# HISTORIC AND DESIGN REVIEW COMMISSION

**HDRC CASE NO:** 2023-007  
**ADDRESS:** 328 E HUISACHE AVE  
**LEGAL DESCRIPTION:** NCB 3088 BLK 4 LOT 7 & E 25 FT OF 6  
**ZONING:** R-4, H  
**CITY COUNCIL DIST.:** 1  
**DISTRICT:** Monte Vista Historic District  
**APPLICANT:** Ramon Torres /Creedco Pros  
**OWNER:** SCHEINMAN AMY LORNA REVOCABLE TRUST  
**TYPE OF WORK:** Reconstruction of a rear accessory structure  
**APPLICATION RECEIVED:** December 29, 2022  
**60-DAY REVIEW:** Not applicable due to City Council Emergency Orders  
**CASE MANAGER:** Edward Hall

## REQUEST:

The applicant is requesting a Certificate of Appropriateness for approval to reconstruct the rear accessory structure at 328 E Huisache, located within the Monte Vista Historic District. The original, rear accessory structure collapsed during construction work due to deteriorated structural members.

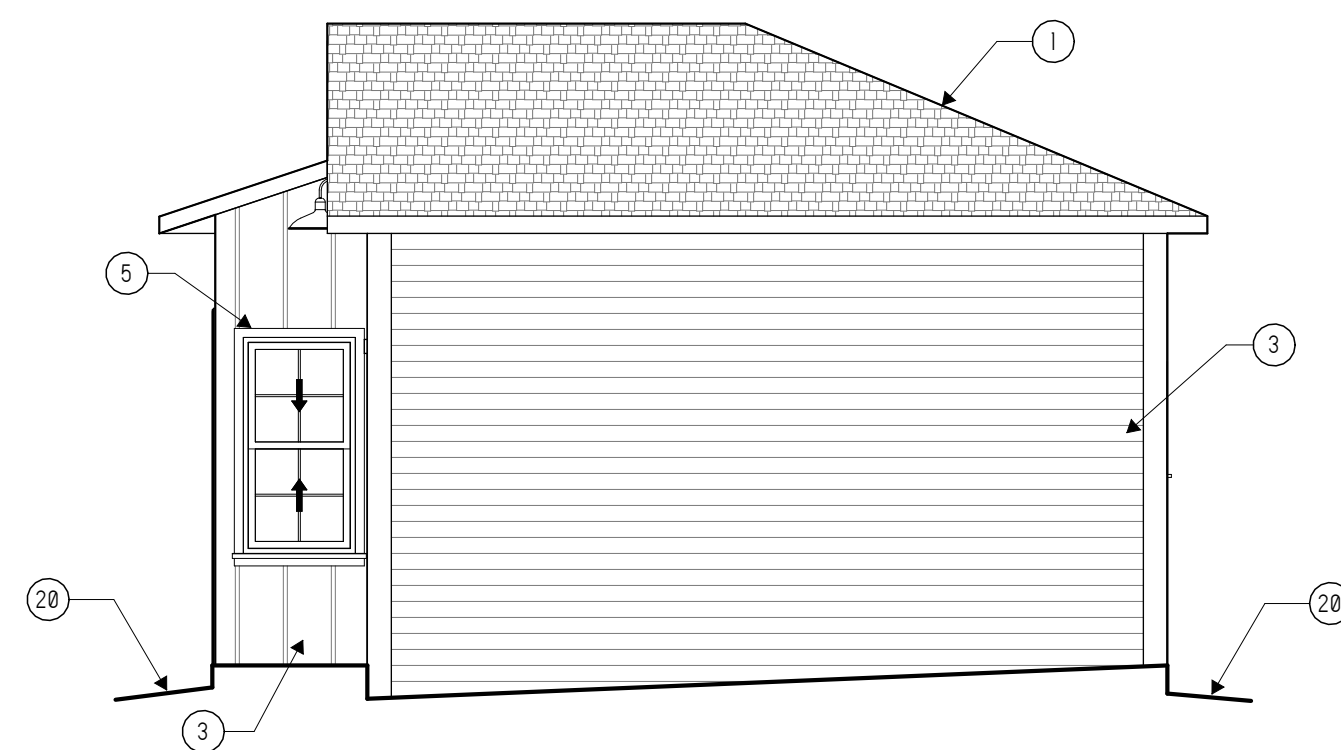
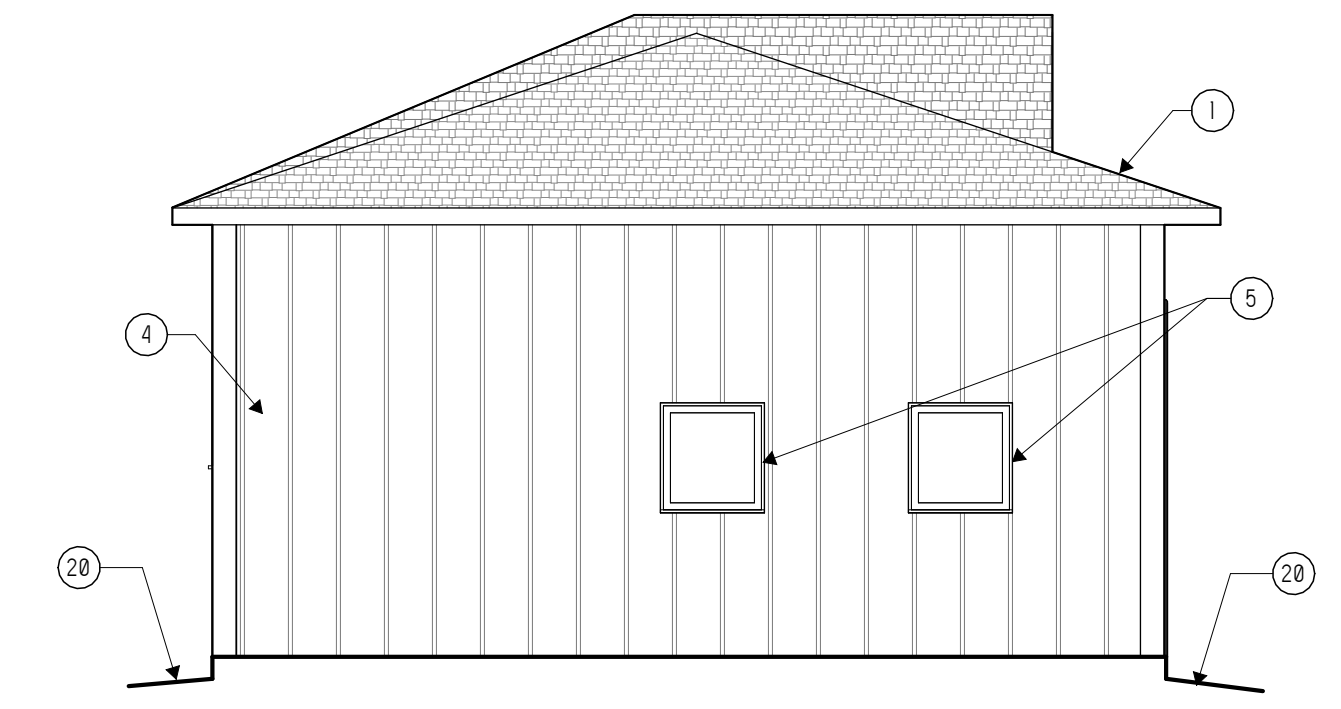
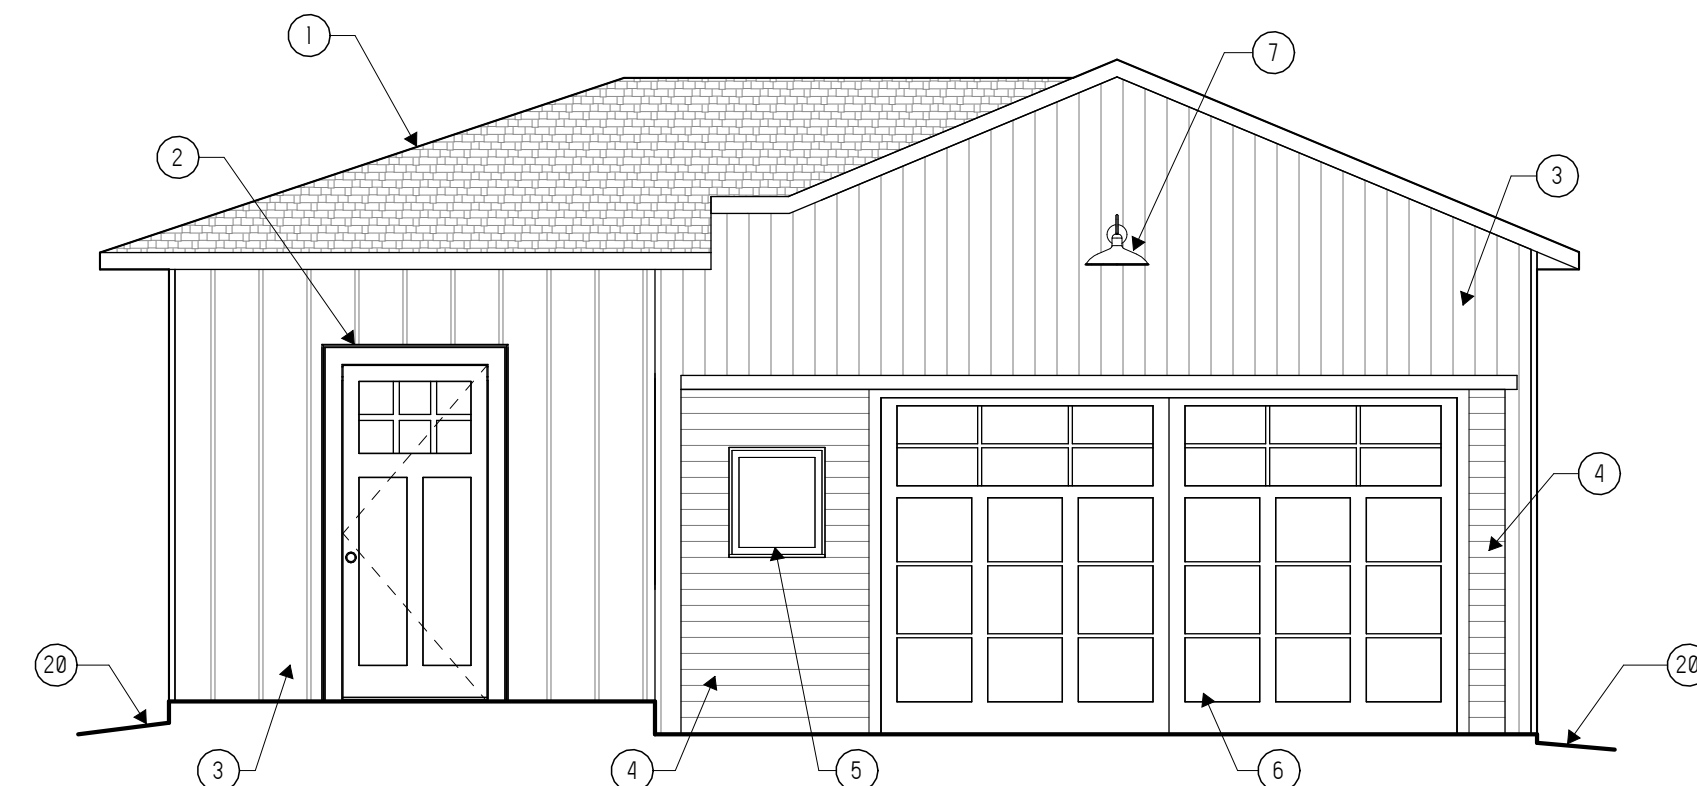
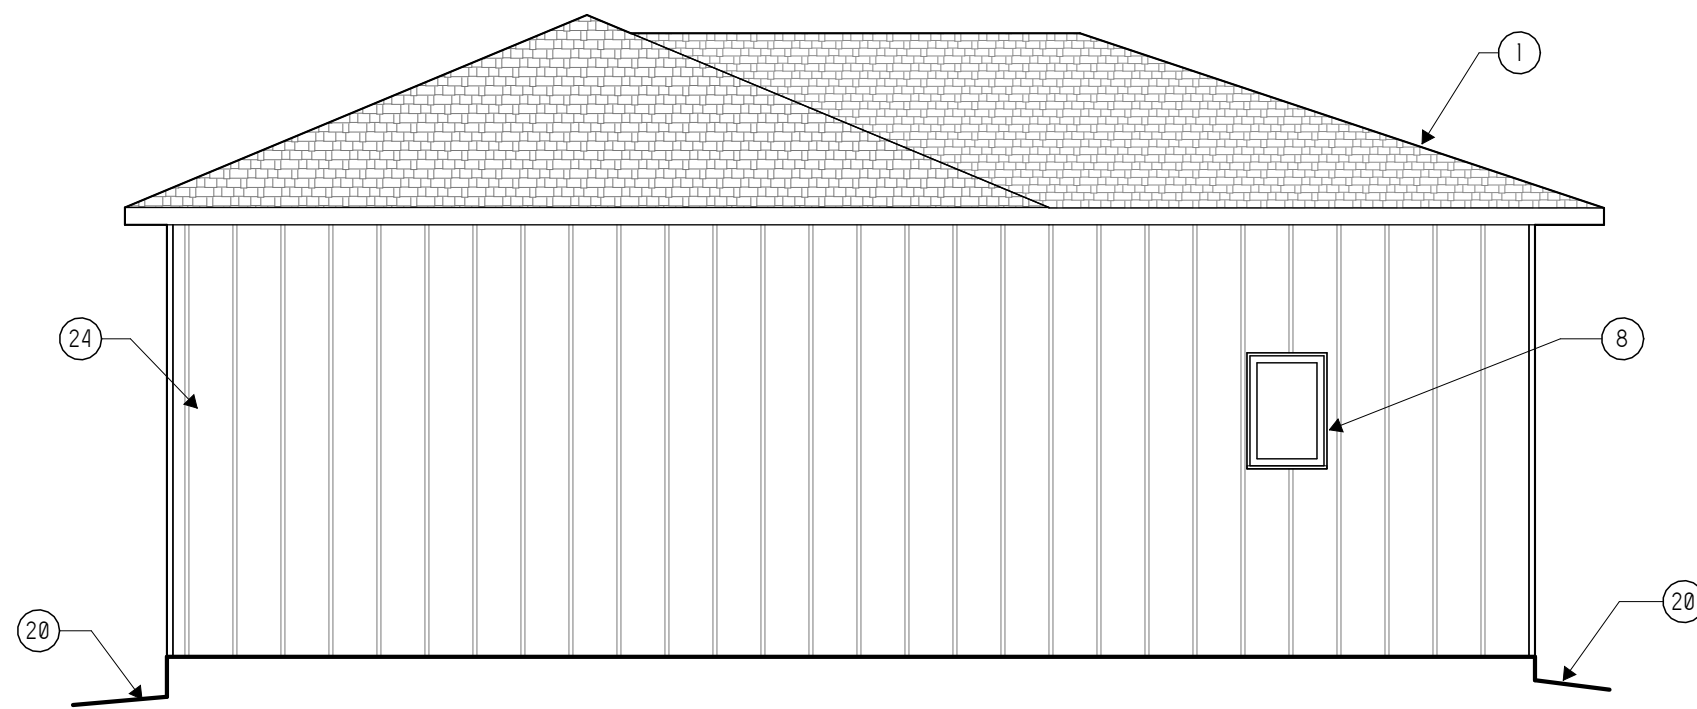
- d. **CONSTRUCTION DOCUMENTS & COMPLETED WORK** – The work that has been completed on site is not consistent with the submitted construction documents. Small inconsistencies, such as siding profiles and window profiles exist.

- f. **ROOF FORM** – The original structure featured a front facing gabled roof, a rear facing hipped roof, and a side room that featured a shed roof. The applicant has proposed to reconstruct the roof structures to feature matching forms as the original. Staff finds this to be appropriate and consistent with the Guidelines for Exterior Maintenance and Alterations 9.B.iii.

- h. **MATERIALS (Siding)** – The original structure featured various siding profiles including vertical lap siding with approximately an eight (8) inch exposure, horizontal siding with approximately a ten (10) inch exposure, and various siding profiles that had been installed over time in non-formal repairs. The applicant has proposed to install all horizontal siding that features a Dutch lap. Per the Guidelines for Exterior Maintenance and Alterations 9.B.iii. outbuildings and garages should be reconstructed based on accurate evidence of the original.

- k. CHARACTER – Generally, staff finds that the character of the original structure has been replicated through this reconstruction; however, staff finds that all boxed gable returns should be eliminated.

- i. That the installed boxed gable returns be eliminated, as noted in finding k.
- ii. That the applicant install salvaged wood windows, as noted in finding i. Salvaged windows should be submitted to staff for review and approval.
